PARKSIDE MONTESSORI MPR AND SITE PROJECT

ADDENDUM NO. 2

Date: November 6, 2023

Project: Parkside Montessori MPR & Site Project
DSA #: 01-120306 41-26

OPTION 2 - PIPE SUPPORT 12
6" = 1'-0"

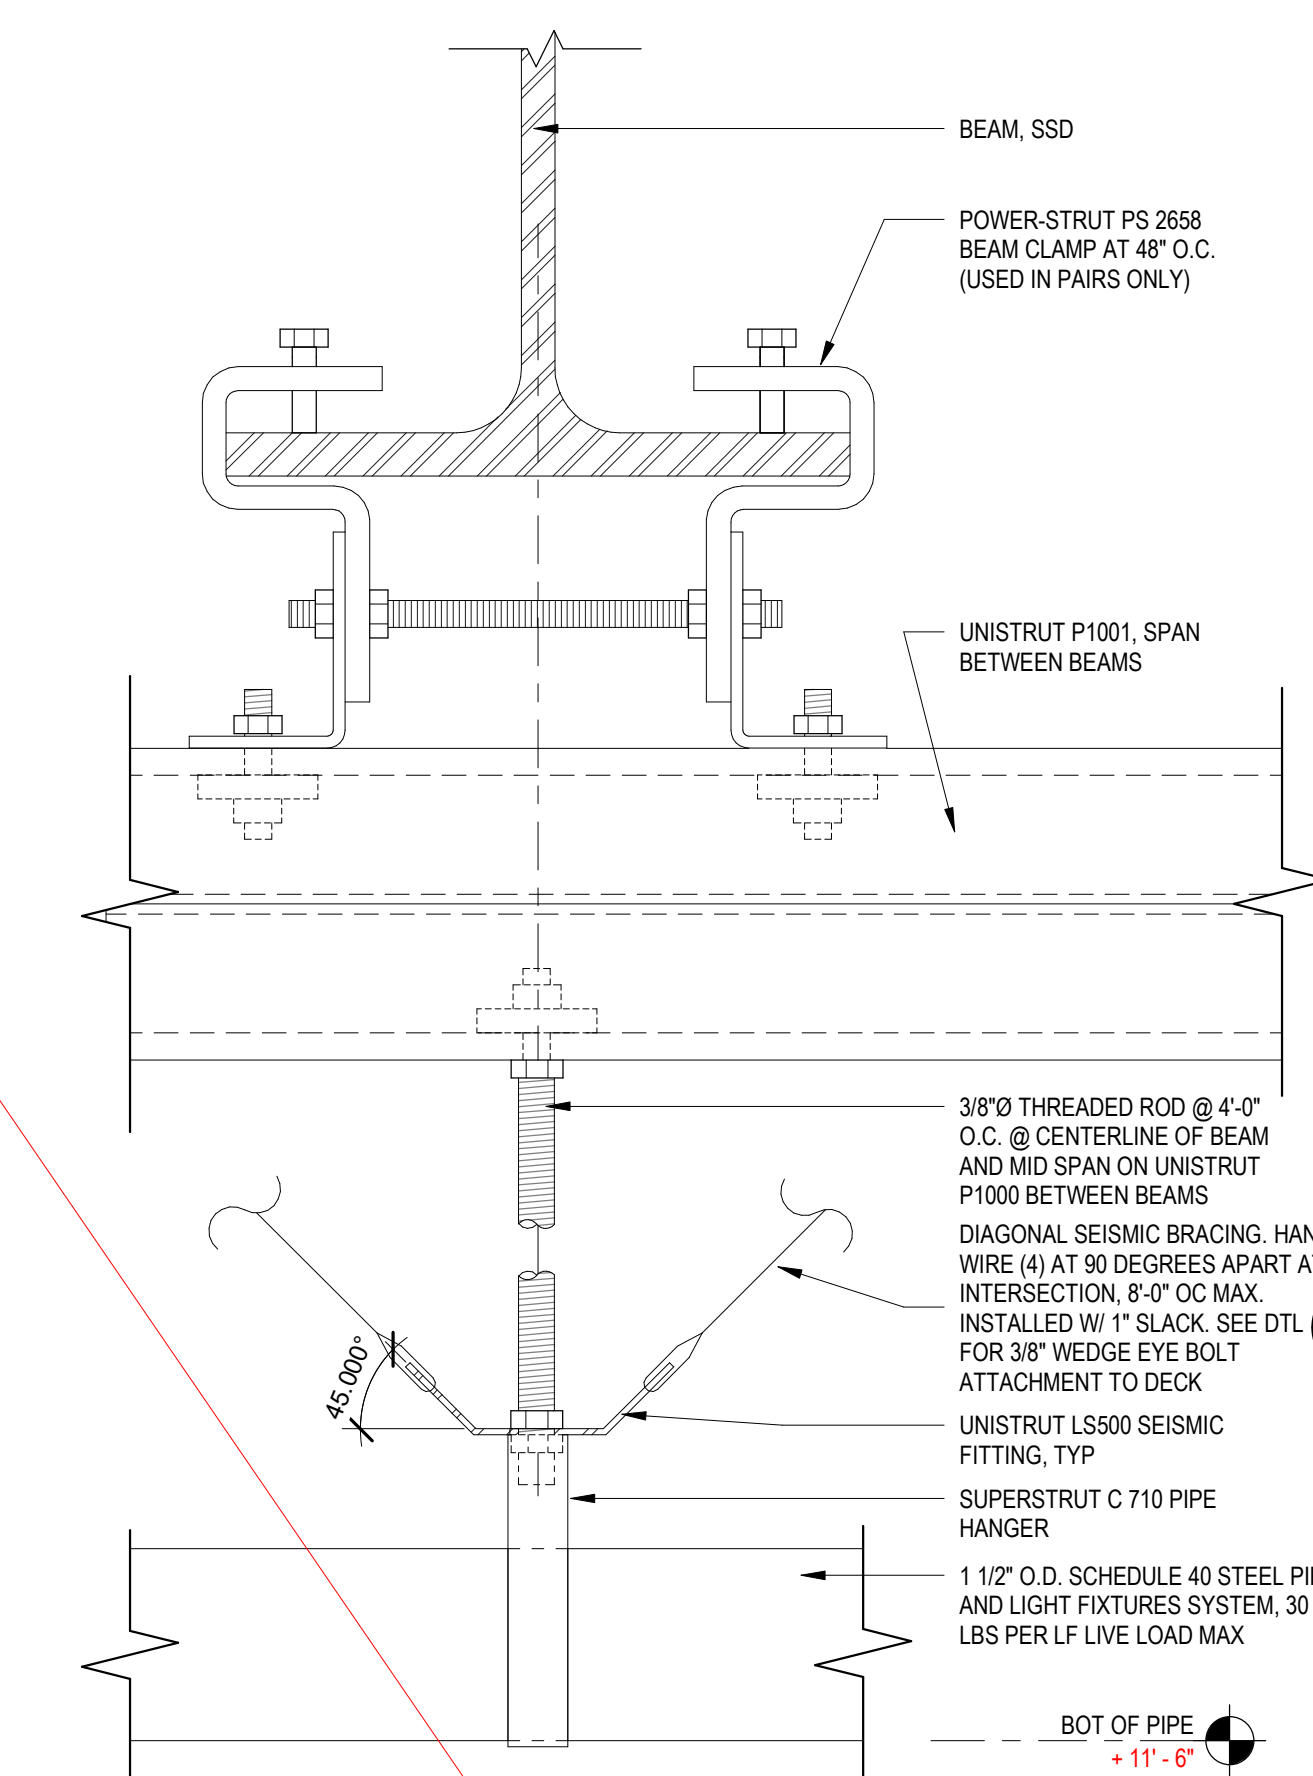
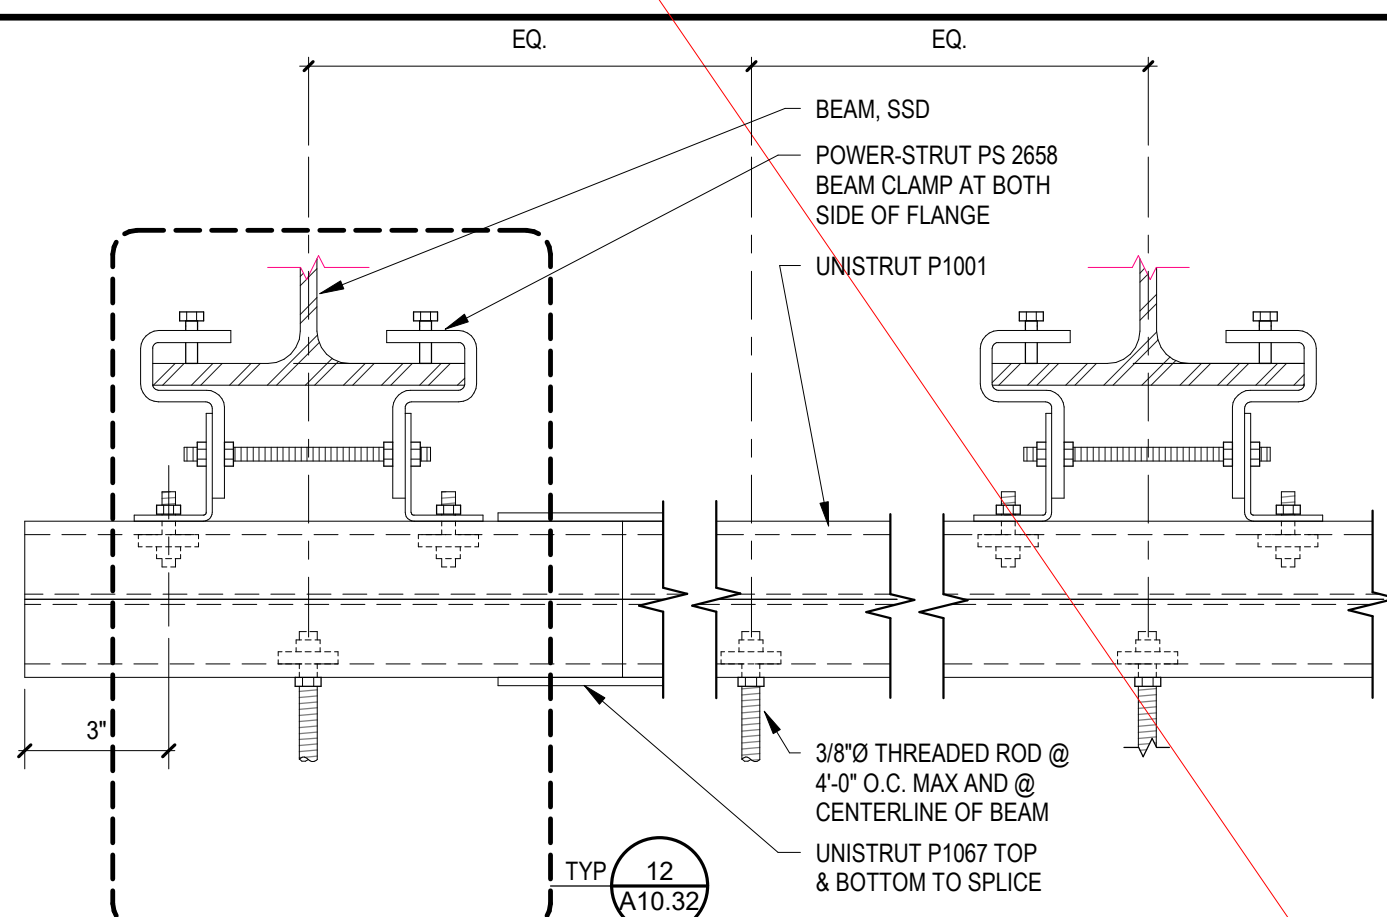
- A. Delete Details 11, 12, 14, 21 associated with theatrical lights support.

24. SHEET ‘E3.1 ELECTRICAL LIGHTING FLOOR PLAN’

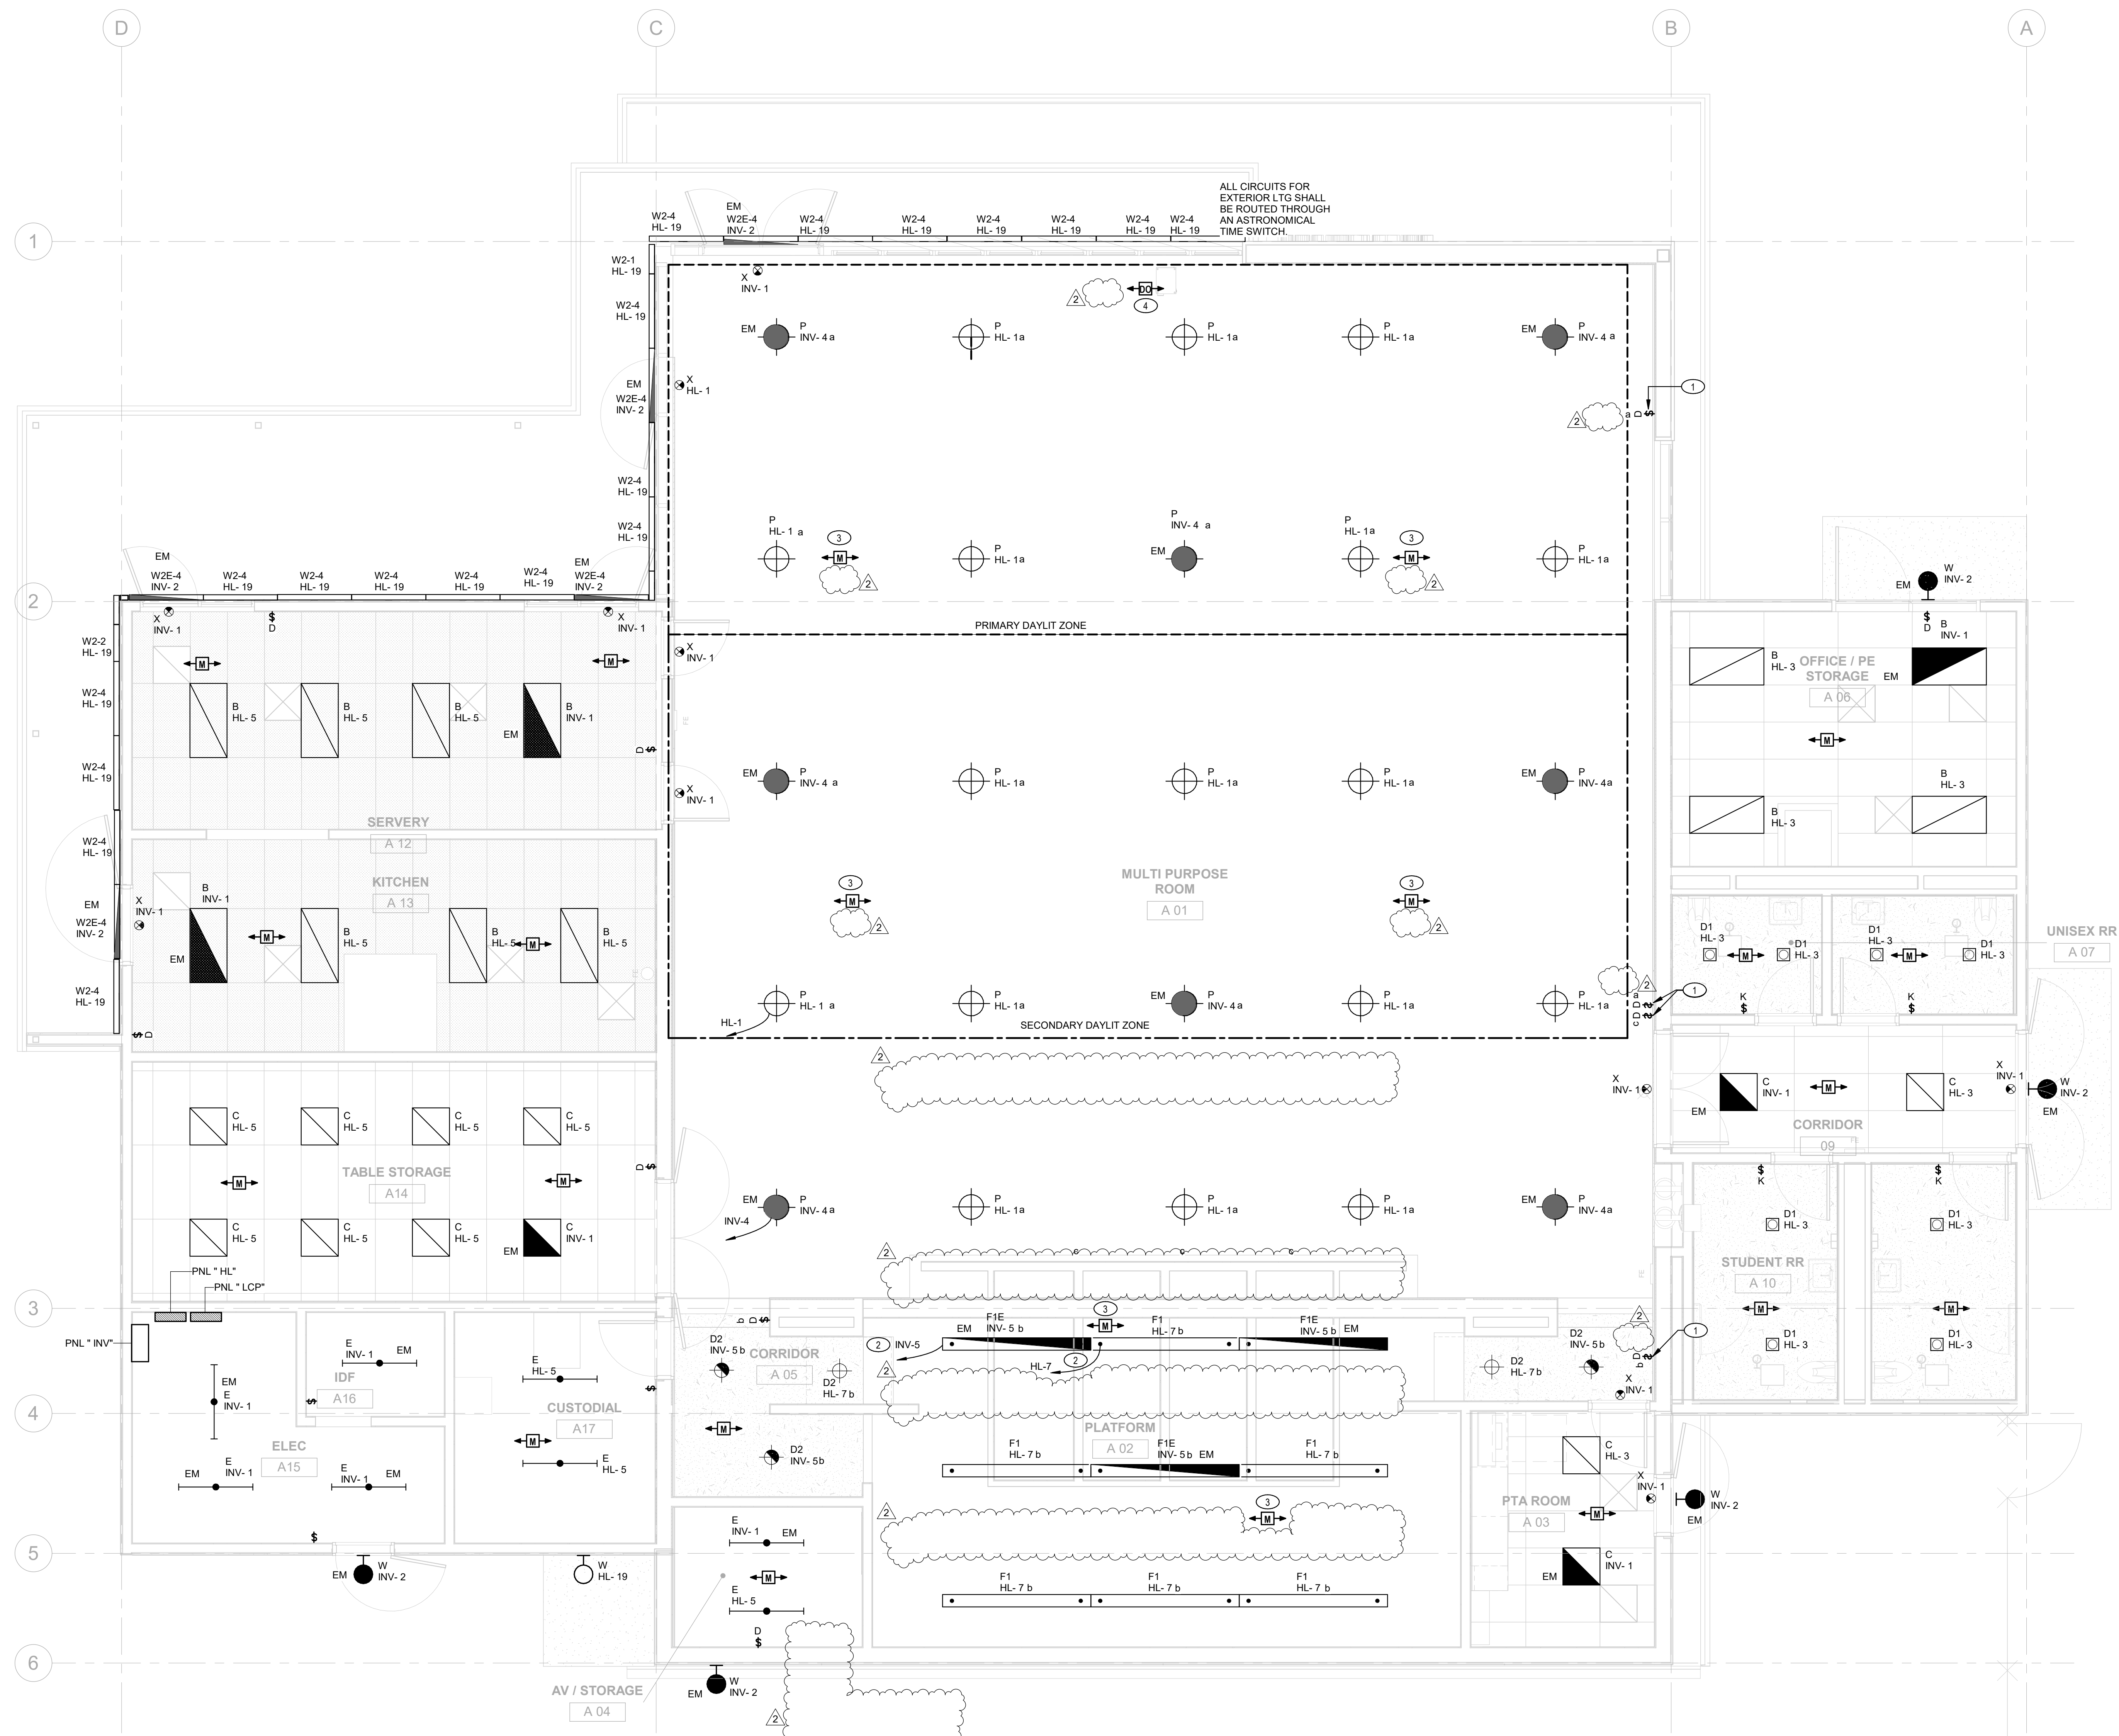
- A. Updated plan to omit theatrical lights.
